ITEM FOR ENVIRONMENTAL COMMISSION AGENDA

COMMISSION MEETING DATE:	March 4, 2020	
NAME & NUMBER OF PROJECT:	HEB 10 SP-2019-0034C	
NAME OF APPLICANT OR ORGANIZATION:	Joe Farias Stantec Consulting Services	
LOCATION:	7901 W US 290 Hwy, Austin, TX 78749	
COUNCIL DISTRICT:	District 8	
Environmental Review staff:	Pamela Abee-Taulli, Environmental Review Specialist Senior, Development Services Department, 512-974-1879	
WATERSHED:	Williamson Creek Watershed, Barton Springs Zone Classification, Edwards Aquifer Contributing Zone, Drinking Water Protection Zone	
REQUEST:	 Variance request is as follows: Request to vary from LDC 25-8-341 to allow cut in excess of 4 feet (maximum cut 7 feet) in the Barton Springs Zone. Request to vary from LDC 25-8-342 to allow fill in excess of 4 feet (maximum fill 14 feet) in the Barton Springs Zone. Request to vary from LDC 25-8-302(A)(1) to construct a building on a slope with a gradient of more than 25 percent. Request to vary from LDC 25-8-302(A)(2) to construct a parking area that is not a parking structure on a slope with a gradient of more than 15 percent.

Project Name:	HEB 10
Ordinance Standard:	Watershed Protection Ordinance
Variance Request:	Reque

EXHIBIT 6 FOR CUT/FILL VARIANCES

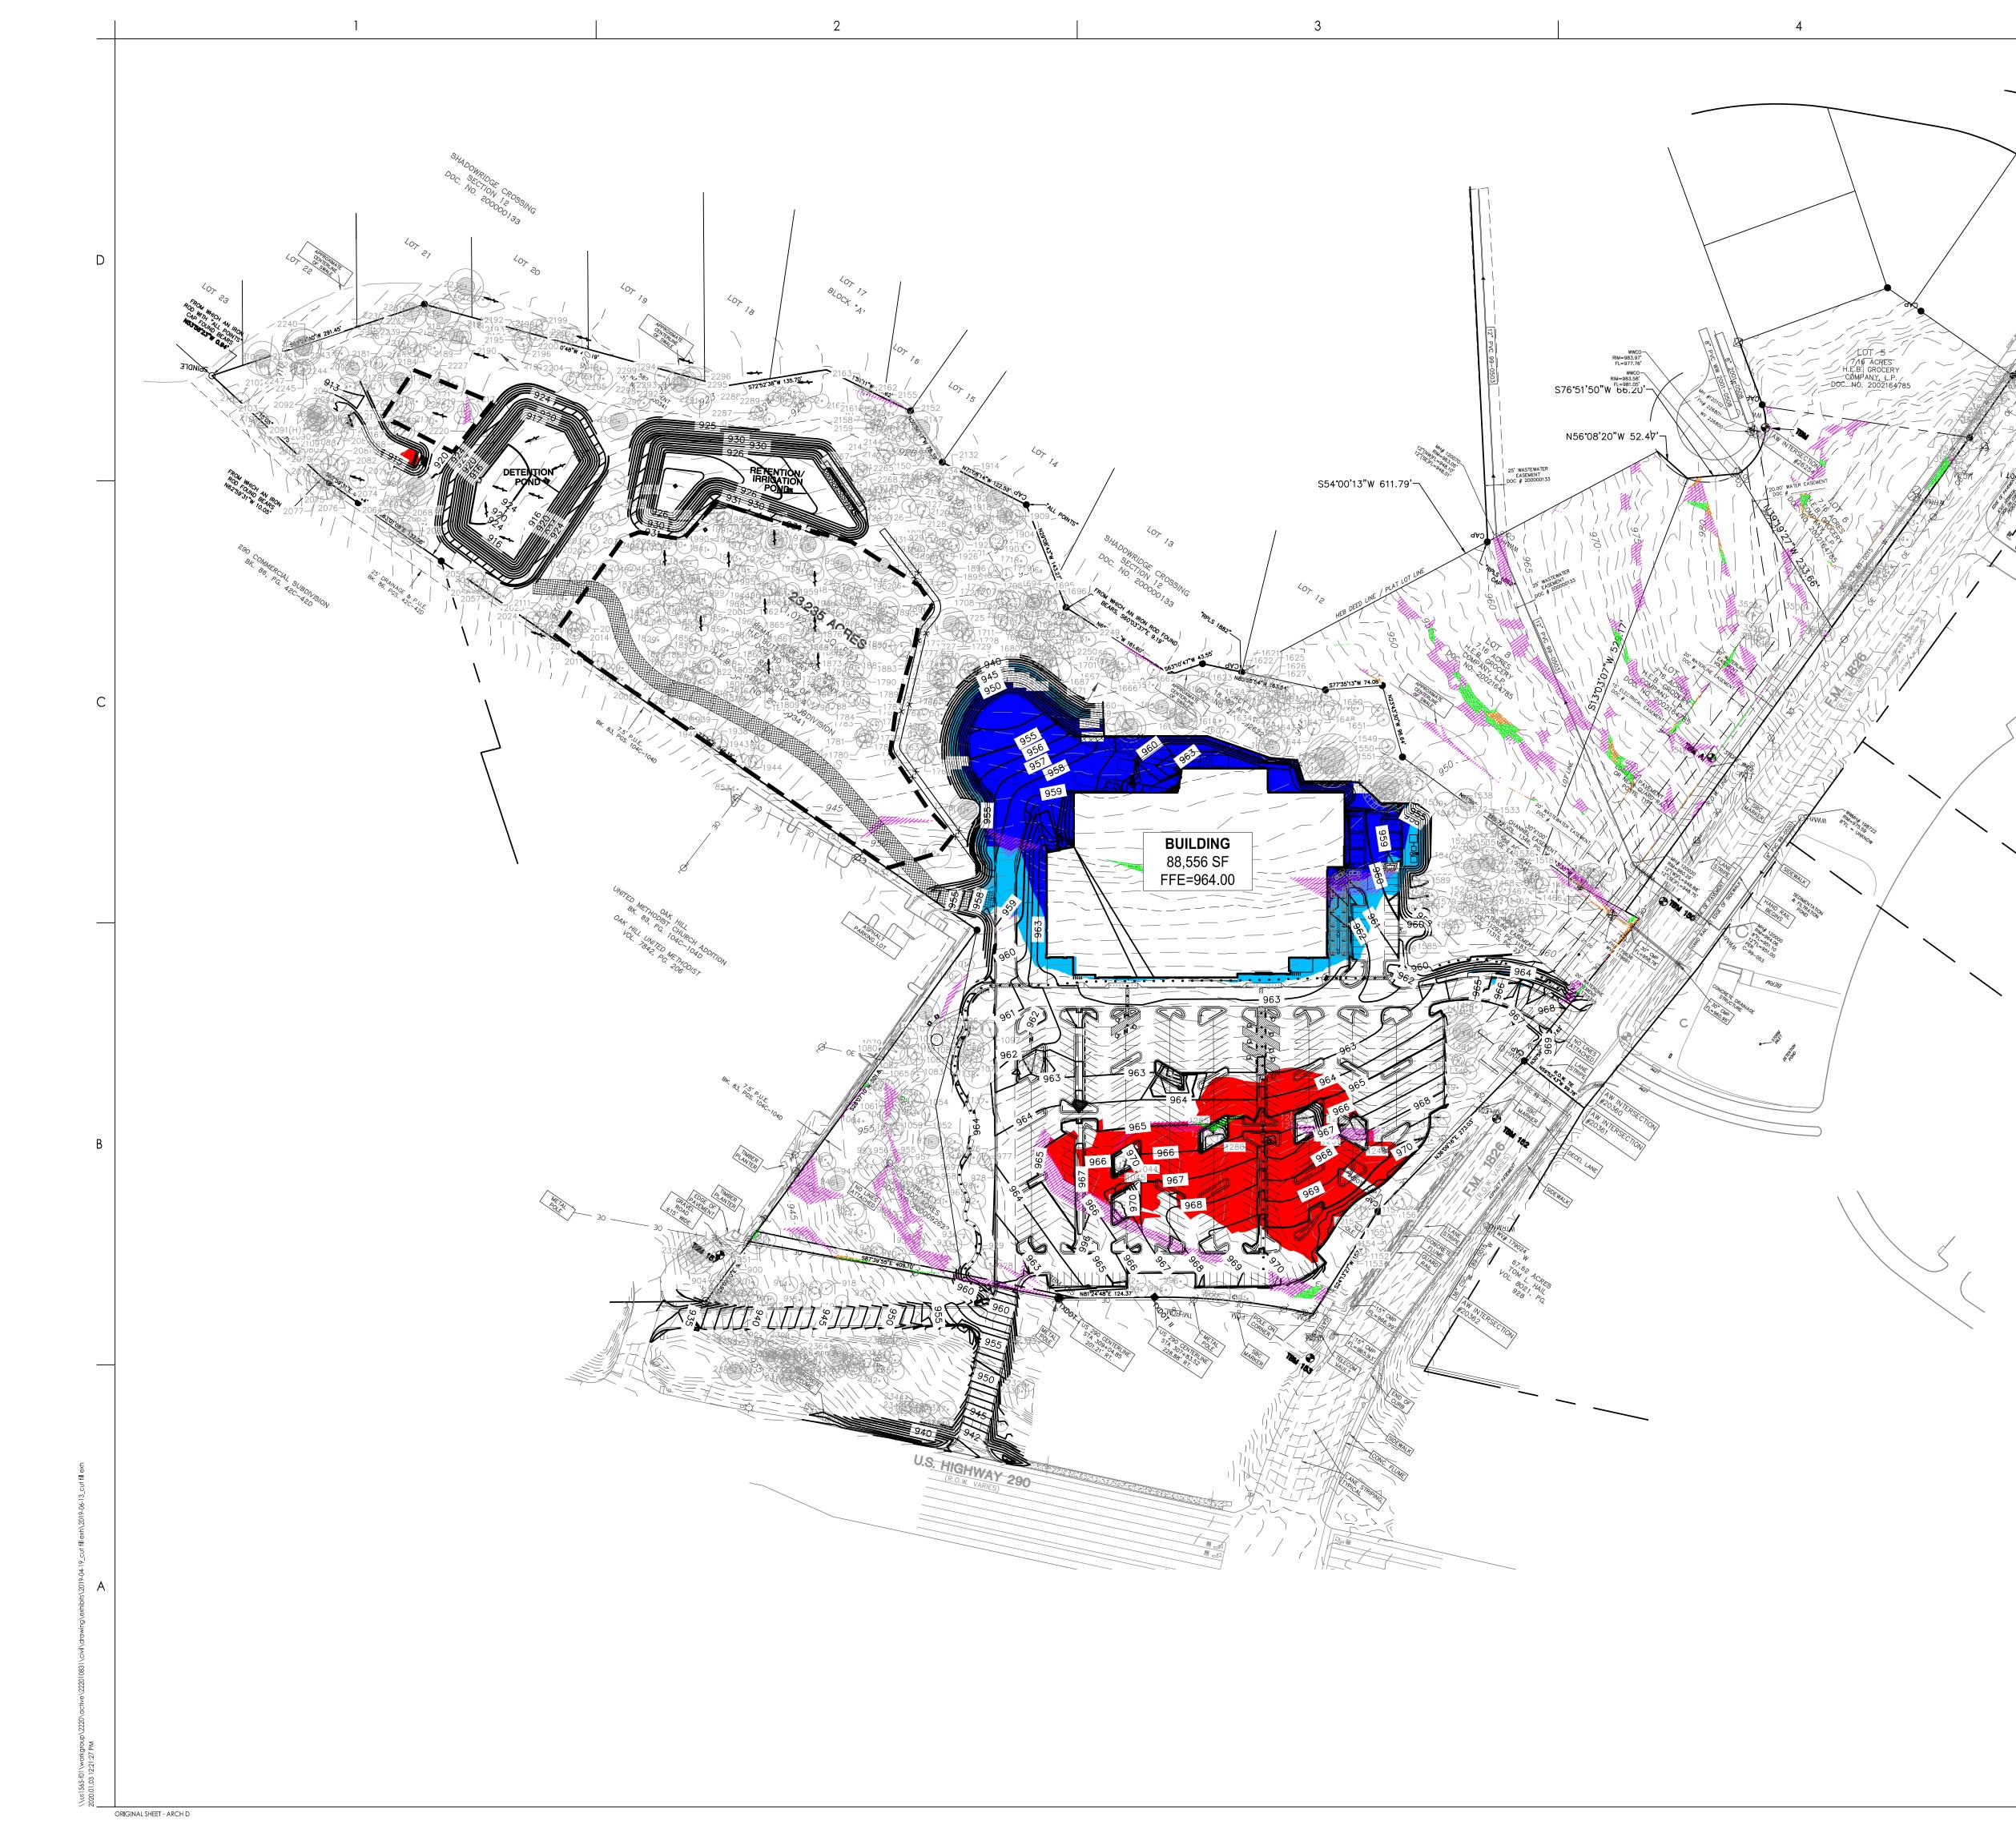
The project has a large footprint, comprised of a surface parking lot and grocery store. The proposed cut between 4 and 7 feet is to level the parking area and make it even with the store.

The project has a large footprint, comprised of a surface parking lot and grocery store. The proposed fill between 4 and 14 feet is to provide a single-level parking lot, grocery store, and access for delivery trucks at the back.

- 5. Cut shall be limited to a maximum of 7 feet and limited to the areas as generally noted on the site plan; and
- 6. Fill shall be limited to a maximum of 14 feet and limited to the areas as generally noted on the site plan.

- 1. Engineered structural containment for fill exceeding 4 feet;
- 2. No non-organic mulch (including stone of any size) allowed in the landscaped areas;
- 3. Rainwater harvesting storage tanks shall have a total volume of at least 3,000 gallons;
- 4. Condensate storage tanks shall have a total volume of at least 3,000 gallons;
- 5. Cut shall be limited to a maximum of 7 feet and limited to the areas as generally noted on the site plan; and
- 6. Fill shall be limited to a maximum of 14 feet and limited to the areas as generally noted on the site plan.
